UNITED STATES PATENT AND TRADEMARK OFFICE

10/669,554

Office Action Summary	Application No.		Applicant(s)	
	10/669,554		RENTZSCH, WOLFGANG	
	Examiner		Art Unit	
	Davienne Monbleau		2878

DETAILED ACTION

Yasushi Fig. 6

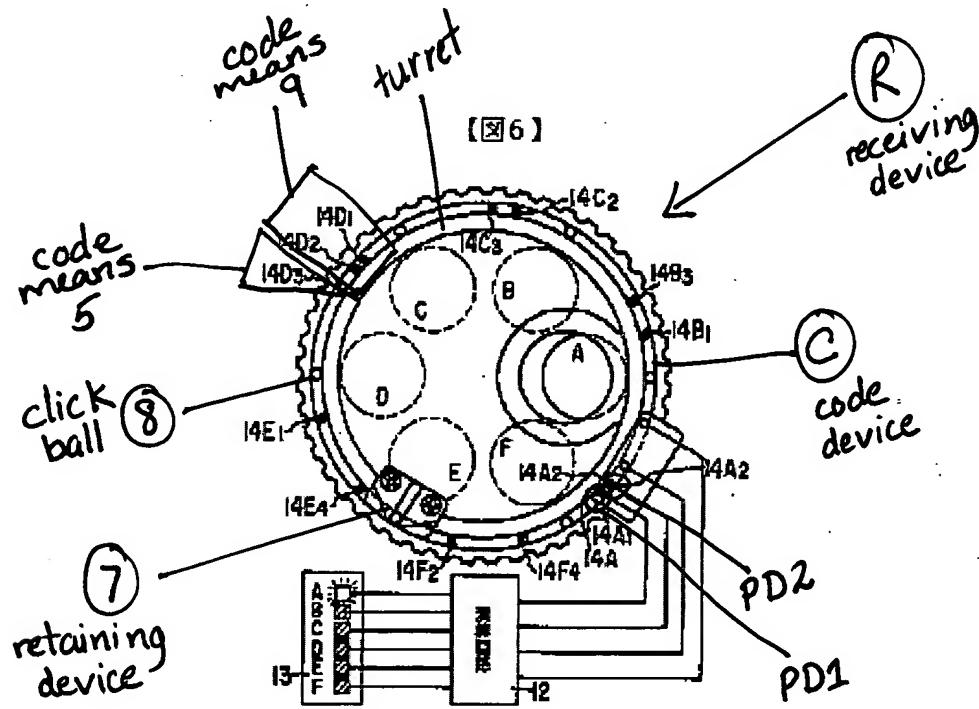
Regarding Claim 1, *Yasushi* discloses in Figures 1 and 6 an apparatus for positioning an optical component, arranged in a receiving device (R) together with several optical components (1A-1F), said apparatus comprising a receiving device (R) being rotatable about an axis and being retainable in several retention positions, said optical component being positionable in a corresponding retention position, a coding device (C) having coding means (14D1, 14D2, 14D3), and two detectors (PD1, PD2) detecting the coding means (14D1, 14D2, 14D3), said two detectors (PD1, PD2) being associated with said receiving device (R) for detecting position of said receiving device (R), and the two detectors (PD1, PD2) detecting coding means (14D1, 14D2, 14D3) at spatially different points, said coding device (C) being embodied in such a way that on the one hand the two detectors (PD1, PD2) detect coding means (14D1, 14D2) simultaneously when the receiving device (R) is located in a retention position, and on the other hand only one of the two detectors (PD1) detects coding means (14D3) when the receiving device (R) is located in a region between two adjacent retention positions. (See Figure 6 below. Please note that Examiner added some notation for clarity in the rejection.)

Regarding Claim 5, *Yasushi* discloses in Figure 6 that coding means (14D1, 14D2, 14D3) are detectable optically.

Regarding Claim 6, *Yasushi* discloses in Figure 6 that the coding means (14D1, 14D2, 14D3) are reflective regions that are arranged substantially transversely to the motion direction of the receiving device (R).

Regarding Claim 8, *Yasushi* discloses in Figure 6 a retaining device (7) arranged in stationary fashion and retains the receiving device (R) in a retention position.

Regarding Claim 9, *Yasushi* discloses in Figure 6 that the retaining device (7) encompasses a ball (8), mounted with force impingement, that as a result of the force impingement presses into a locking notch provided on the receiving device (R). The retaining device (7) is a click spring and thus inherently uses force impingement with a notch.

Regarding Claim 10, *Yasushi* discloses in Figure 6 that the two detectors (PD1, PD2) are arranged with respect to one another in such a way that they detect the coding means (14D1, 14D2, 14D3) at an effective distance D.

Regarding Claim 11, *Yasushi* discloses in Figure 6 that the coding device (C) is embodied in such a way that in each retention position of the receiving device (R) there is provided, at the points of the coding device (C) detected by the detectors (PD1, PD2), a coding means (14D1, 14D2) which has an effective width B that is equal to the effective distance D of the detectors (PD1, PD2).

Regarding Claim 12, *Yasushi* discloses in Figure 6 that the coding device (C) is embodied in such a way that there is provided in each retention position of the receiving device (R), at the points of the coding device (C) detected by the detectors (PD1, PD2), a coding means (14D1, 14D2) which has an effective width B that is less than the width E of the capture region of the retaining device (7).

Regarding Claim 18, *Yasushi* discloses in Figure 6 a control device (12, 13, and 51) which processes detected signals of the two detectors (PD1, PD2). It is inherent that the control device also controls the motor device in order to align an optical component in a retention position.

Regarding Claim 19, *Yasushi* discloses in Figure 6 that the receiving device (R) encompasses a turret for the reception of microscope objectives.

Regarding Claim 21, *Yasushi* discloses in Figure 6 that an initialization of the apparatus for positioning an optical component is accomplished by rotation or motion of the receiving device (R) through at least one retention position, the detected signals of the two detectors (PD1, PD2) being detected and evaluated.
